SUBMISSION

a written submission by way of objection

3 NOVEMBER 2025

RE: **SSD-76220734**
156 OCEAN STREET, NARRABEEN NSW 2101
INDIGO BY MORAN
SENIORS HOUSING
WRITTEN SUBMISSION: LETTER OF OBJECTION
SUBMISSION: TULLOCH

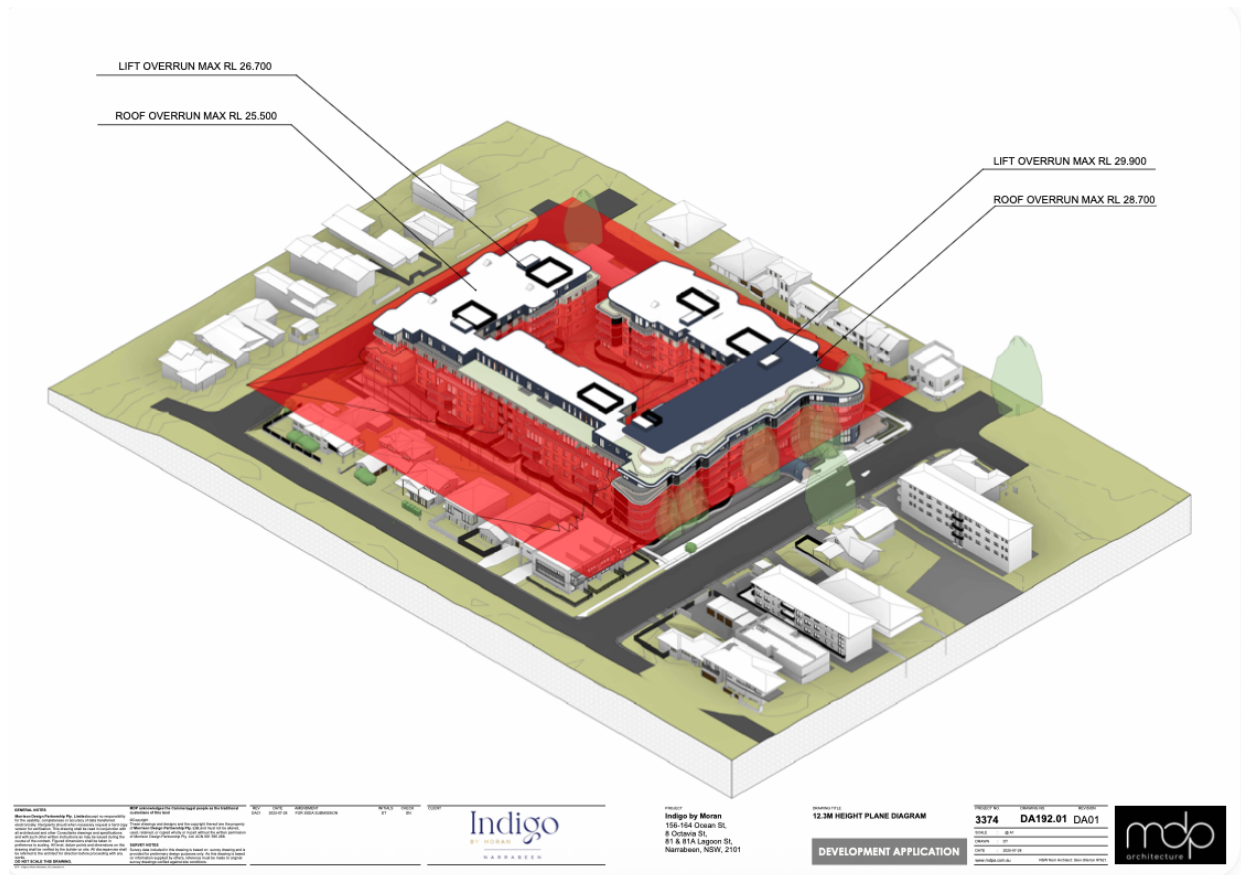
The above diagram shows the massive non-compliances within the proposal. The proposed building height of 21.1m represents an 8.8m or 71% departure from the Development Standard with Bonus [8.5m + 3.8m], and this massive non-compliance causes the proposed development to be inconsistent with all SEPP, LEP & DCP standards and controls, and fails all objectives. The proposed SIX STOREY MASSIVE DEVELOPMENT adjacent 8.5m HOB zones with predominantly ONE to TWO STOREYS is plainly unacceptable.

I ask that the Height Blanket be checked, so that the base levels accord with the Registered Surveyors Drawing.

Figure 25 Interface with Surrounding Sites

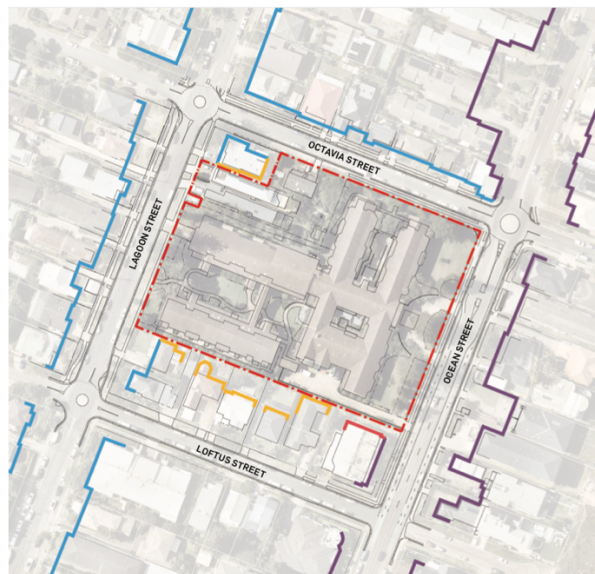
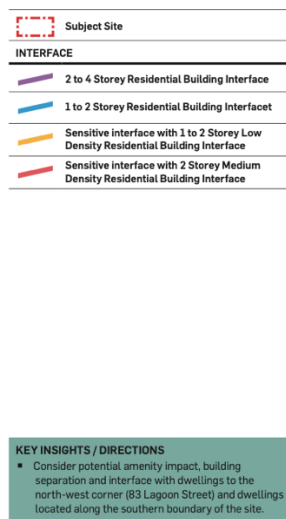
The built form should respect the built form interface, and present similar two/three storey development facing Loftus Street dwellings, Octavia Street and Lagoon Streets.
